UNITED STATES PATENT AND TRADEMARK OFFICE

APPLICATION NO.	FILING DATE	FIRST NAMED INVENTOR	ATTORNEY DOCKET NO.	CONFIRMATION NO.	
10/700,620	11/05/2003	Junichi Noro	02410345AA	4870	
30743	7590 06/03/2005		EXAM	INER	
WHITHAM, CURTIS & CHRISTOFFERSON, P.C. 11491 SUNSET HILLS ROAD			VY, HU	VY, HUNG T	
SUITE 340	ar made Komb		ART UNIT	PAPER NUMBER	
RESTON, V	RESTON, VA 20190			2821	
			DATE MAILED: 06/02/2006

DETAILED ACTION

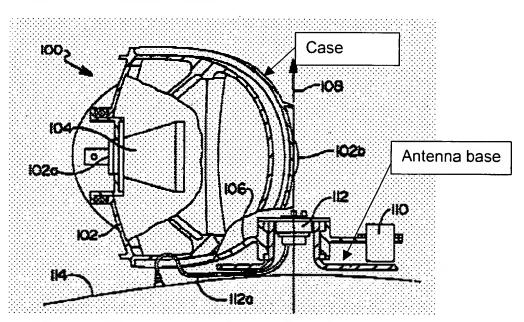
Claim 1, Asano et al. disclose an antenna apparatus, comprising: an antenna element 109, having directivity in a vertex direction; an antenna case 104, containing the antenna element 109; an antenna base 101, coupled to the antenna onto an installation face; and an angle regulator 103, adjusting a relative antenna case 104 and

the antenna base 101 case, and attached angle 112 between the antenna case 104 and the antenna base 101(See fig. 2).
